# Waiohine FMP - Flood Modelling and Mapping Audit

Prepared for Greater Wellington Regional Council

Prepared by Beca Ltd (Beca)

9 May 2017

Figure A1 Overall Planning Map – pre-FMP options

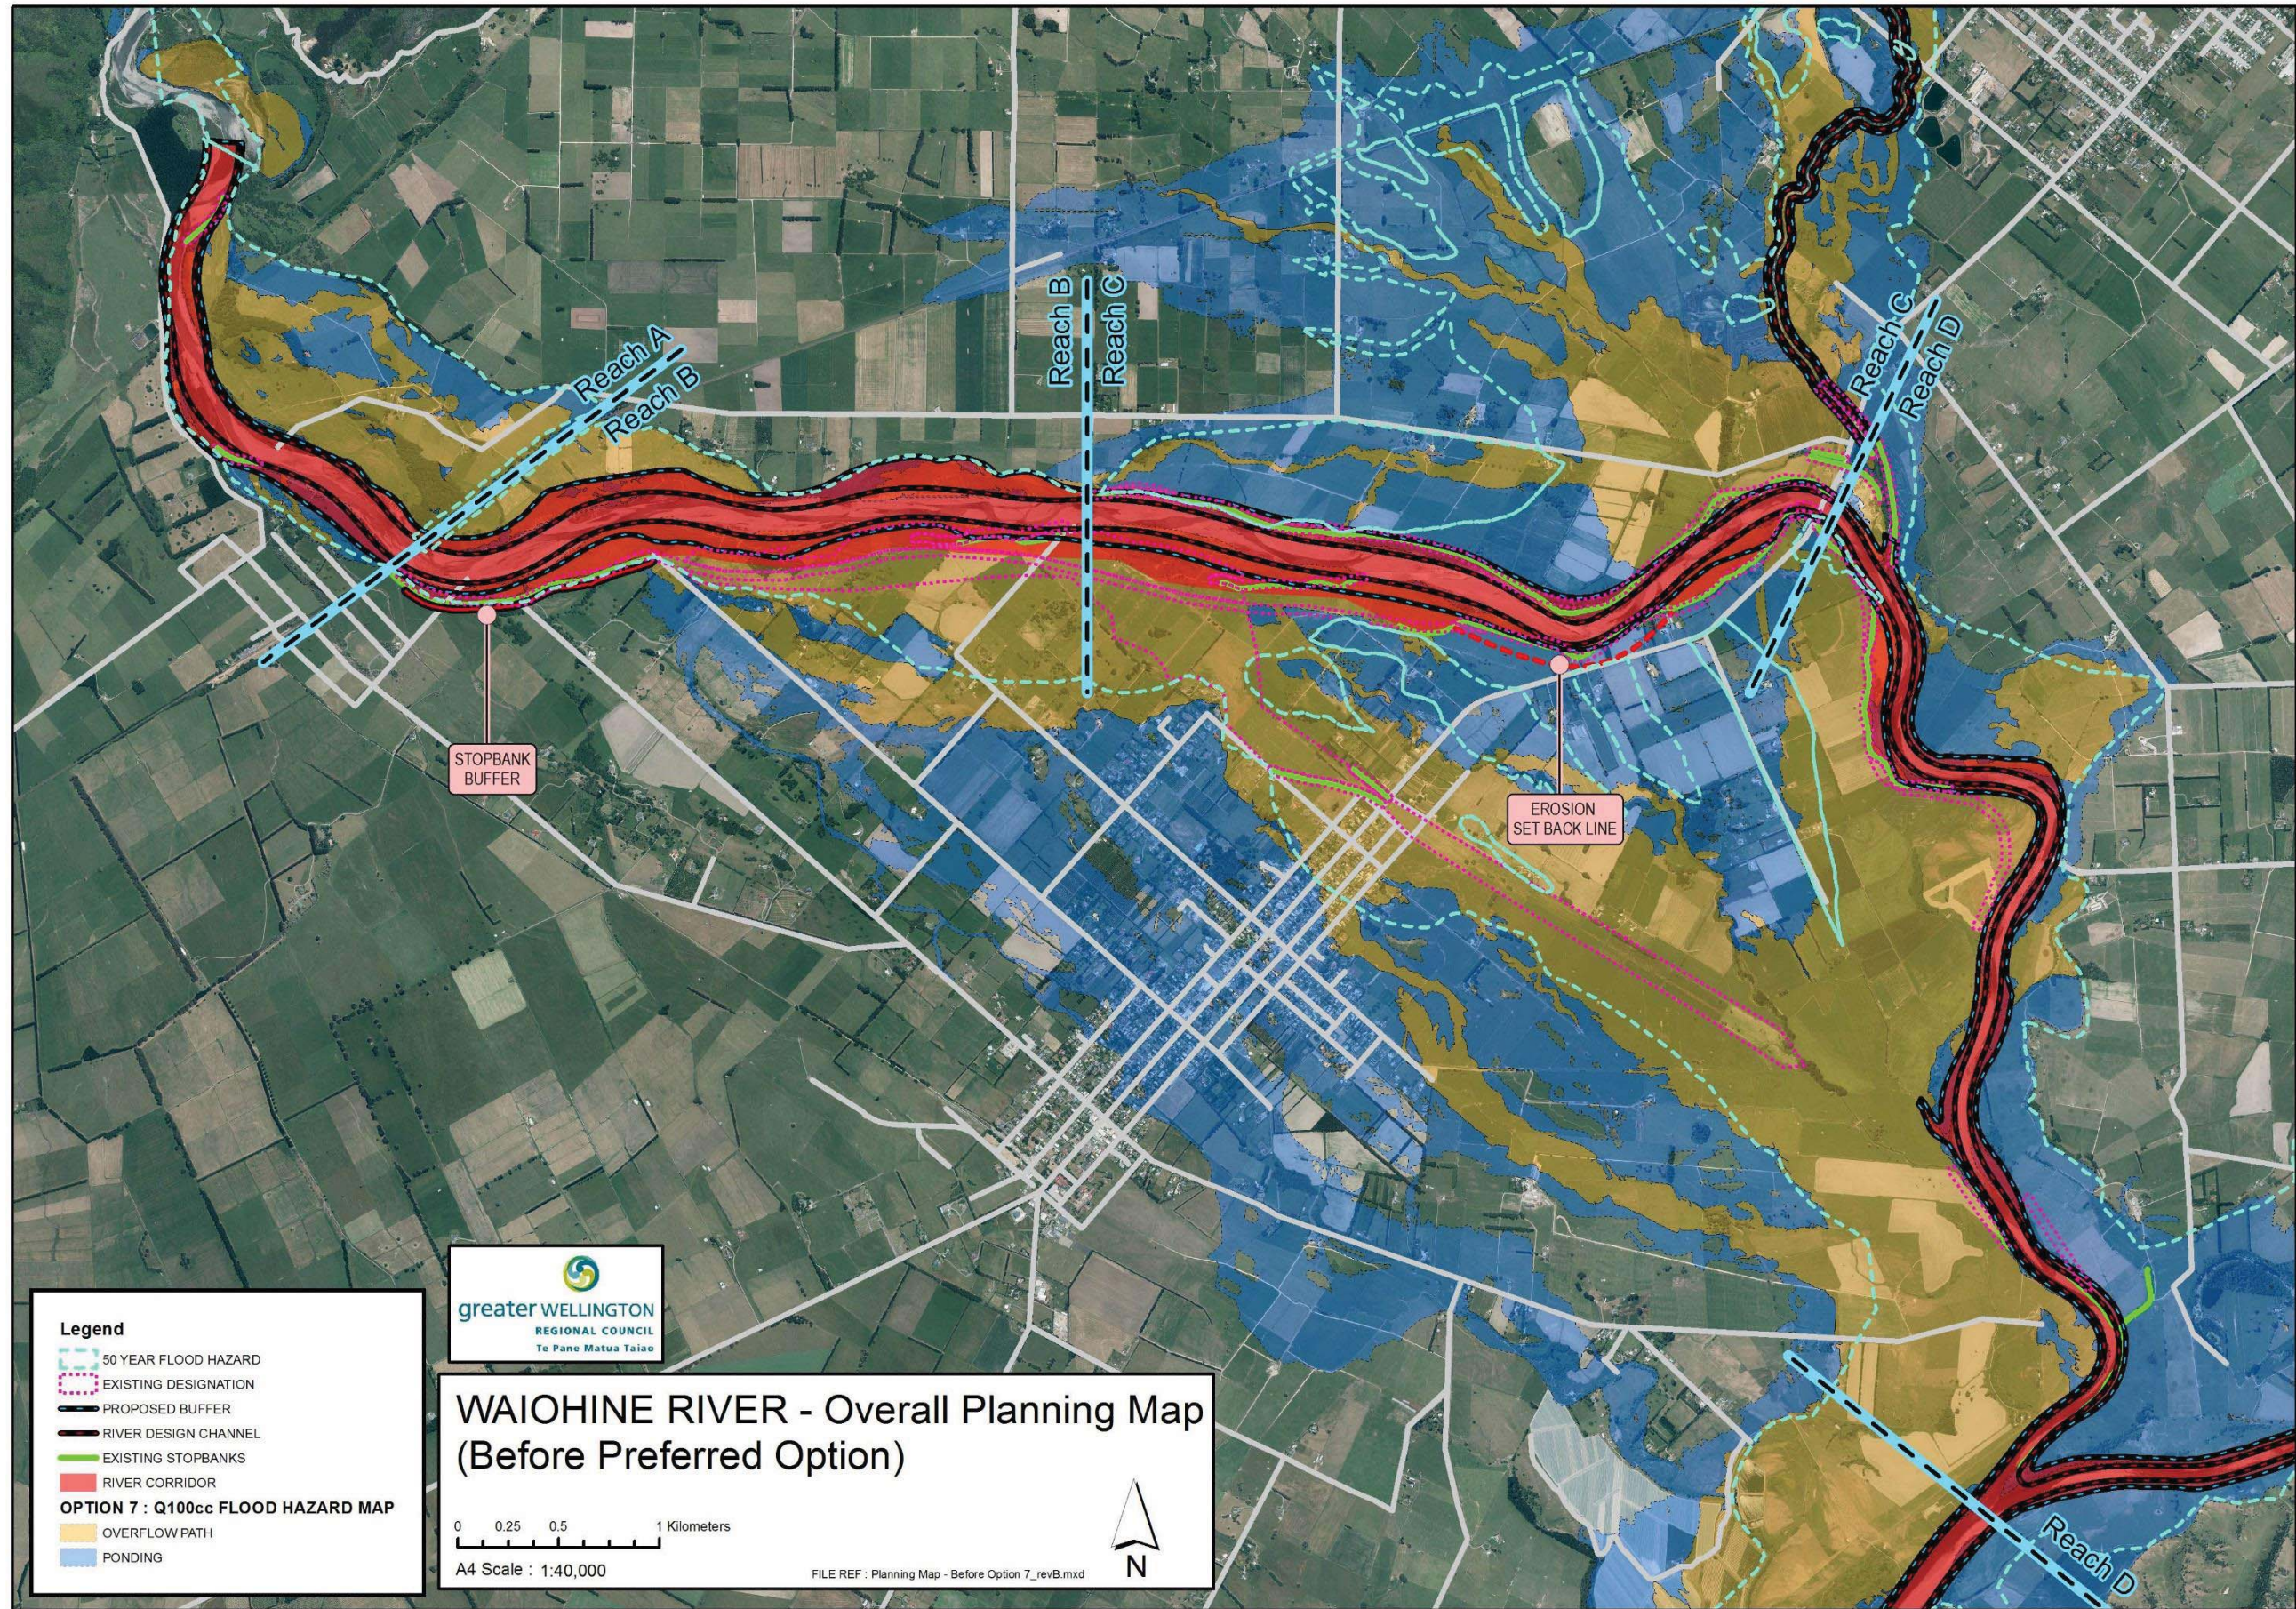
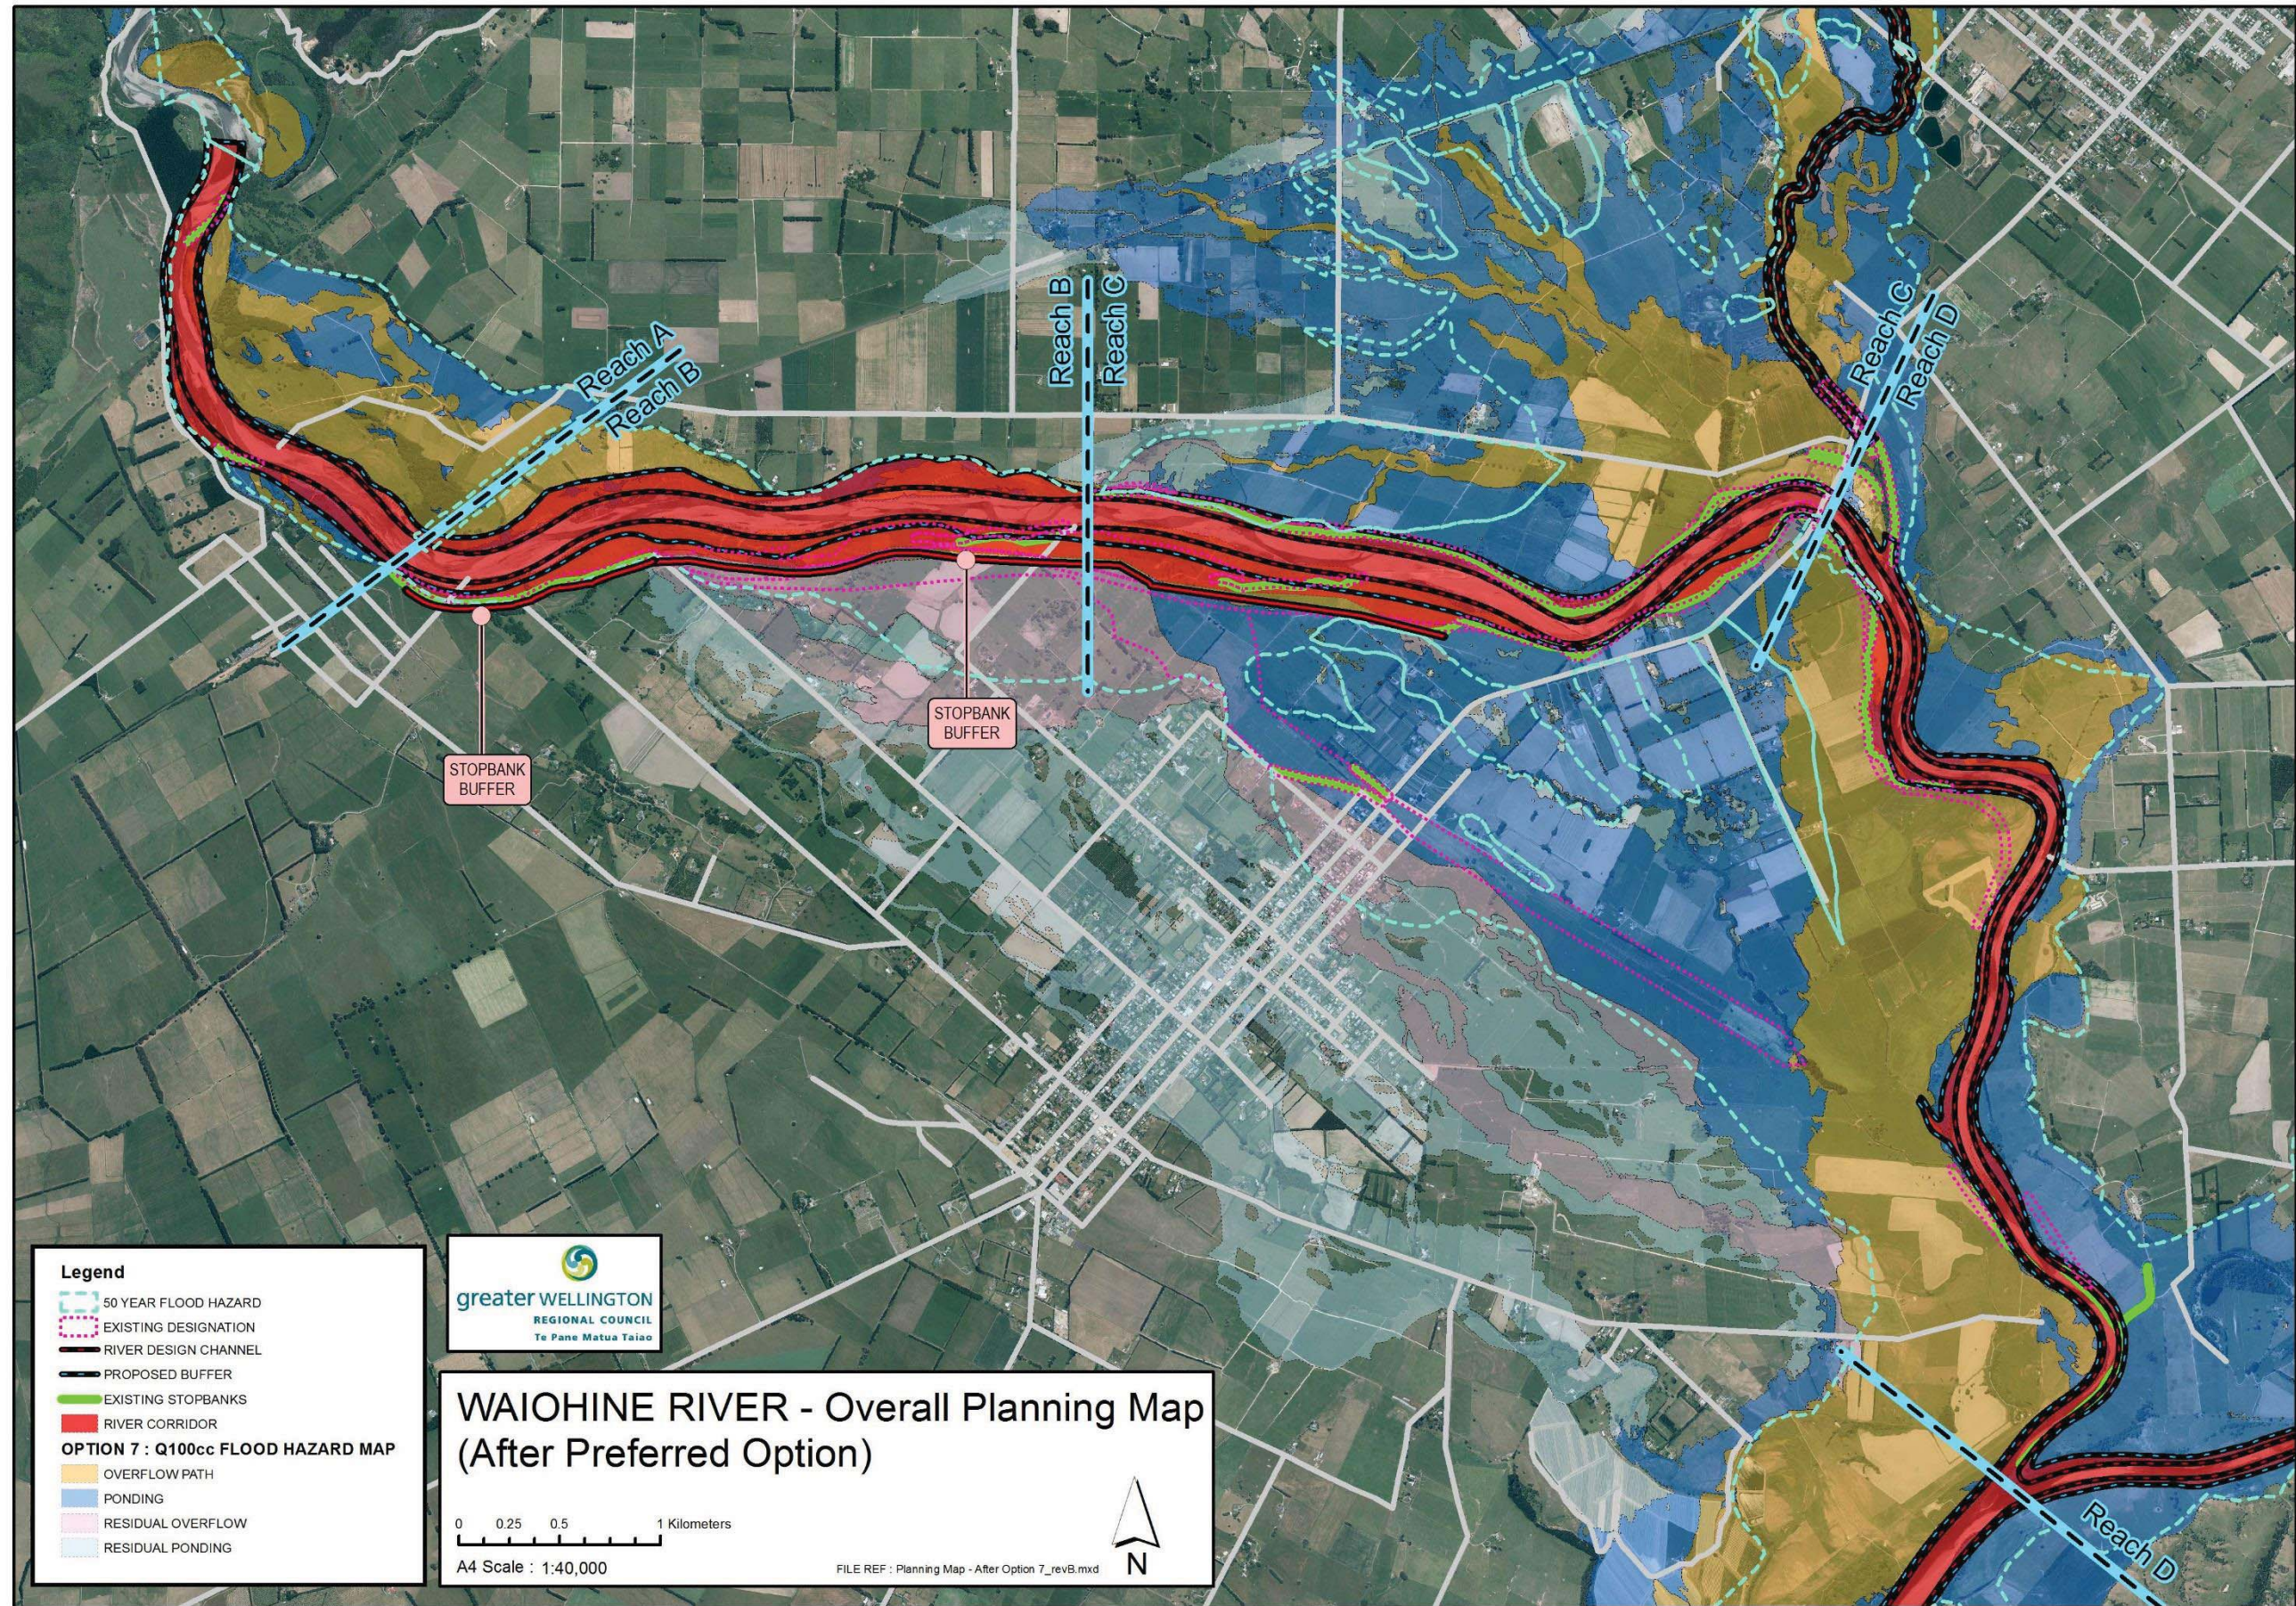
Item	Comment	Audit rating	Fit for Use
Access to the flood maps	<p>As part of the audit, GWRC provided copies of model files, results, outputs and images. These included the Overall Planning Maps shown in Figures A1 and A2, as well as some larger scale images.</p> <p>An internet search for “Greytown Flood Hazard Map” leads to the <a href="http://mapping.gw.govt.nz/Wairarapa/">http://mapping.gw.govt.nz/Wairarapa/</a> website (below), where it is possible to see flood outlines for the 50 and 100-year ARI flood hazard zones. This website is a joint initiative of the three Wairarapa district councils, and it is important that flood information shown is not different from GWRC’s latest flood maps.</p> 	2	Review

Item	Comment	Audit rating	Fit for Use
	<p>It is not possible determine flood depths or velocities from the maps, and the legend does not indicate whether the flood outlines include an allowance for climate change or modelled freeboard.</p> <p>The maps legend includes an item labelled “for flood info see WRC”. It is assumed that “WRC” is GWRC.</p> <p>For detailed site-specific information, users are required to contact GWRC and can be provided with site maps of flood depths and velocities. These are pixilated to the 10 m grid, which can cause anomalies in interpretation, as discussed in Section 5.2. Use of smaller grid sizes (or flexible mesh) for flood modelling, and post-processing flood levels to generate smooth flood outlines based on detailed underlying topography can remove issues of pixilation.</p>		
<b>Application of freeboard</b>	<p>As discussed in the last item in Table 4.4, freeboard is added during the hydraulic modelling and not during the preparation of the maps. This is an approach that has been used elsewhere by GWRC, but can be confusing for differentiating those areas within the ‘non-freeboard’ flood extent, and for explaining what flood velocity information in those areas relates to.</p> <p>A review of how it is best implemented has been recommended.</p> <p>The published flood maps should state whether or not freeboard has been applied.</p>	2	See Table 4.4

<b>Scenarios</b>	<p>The Overall Planning Maps show the Q100cc (100-year ARI plus an allowance for climate change) Overflow paths and Ponding areas, while the <a href="http://mapping.gw.govt.nz/Wairarapa/">http://mapping.gw.govt.nz/Wairarapa/</a> website shows the 50 and 100-year ARI flood hazard areas.</p>	1	Yes
<b>Presentation of flood hazard maps</b>	<p>The legend of the Overall Planning Maps refers to them being Flood Hazard Maps, while the website legend indicates that the shaded areas are Flood Hazard Areas.</p> <p>However, both sets of maps show the flood extents for the 50 or 100-year ARI flood using a single shading for the whole flood hazard extent. This does not give a full understanding of the hazard in each location.</p> <p>‘Flood hazard’ is the term used by GWRC for flood extent maps. Elsewhere, the term ‘flood hazard’ often refers to a value related to both flood depth and the water velocity. This is useful from a hazard assessment perspective to understand potential danger to people and buildings, and can be readily calculated from the outputs of 2D hydraulic models.</p> <p>This suggests that using the term ‘hazard’ in the title of the GWRC maps may be confusing (especially for those areas that are only shown to be at risk once freeboard has been added) and that an alternative name should be used for the information shown on these maps.</p> <p>The terminology currently used may be one of the reasons why some sections of the local community are struggling to accept the current maps. This may be especially the case in areas where the local community do not perceive that certain areas are at risk of flooding, and that inclusion within the mapped flood hazard extent could adversely affect the value or development potential of those areas or property.</p> <p>Subject to the underlying flood modelling being fit for use, the information on the flood maps is useful, but the terminology could be improved to avoid confusion, as has occurred in other catchments in the region.</p>	1	Yes

The review of the flood hazard maps used for planning purposes indicates that the maps are a true reflection of the outputs of the hydraulic flood modelling. However, the map legends could be improved to better describe the information being displayed and the provenance of that information. It should be clearly stated whether the maps include model freeboard and an allowance for climate change.

Map legends, descriptions and terminology should be improved. Improvements to online access to the flood maps and detailed flood information should be reviewed. Post-processing of flood model outputs should be considered to improve the rendering of flood maps and reduce anomalies as a result of pixilation caused by the 10 m model grid.
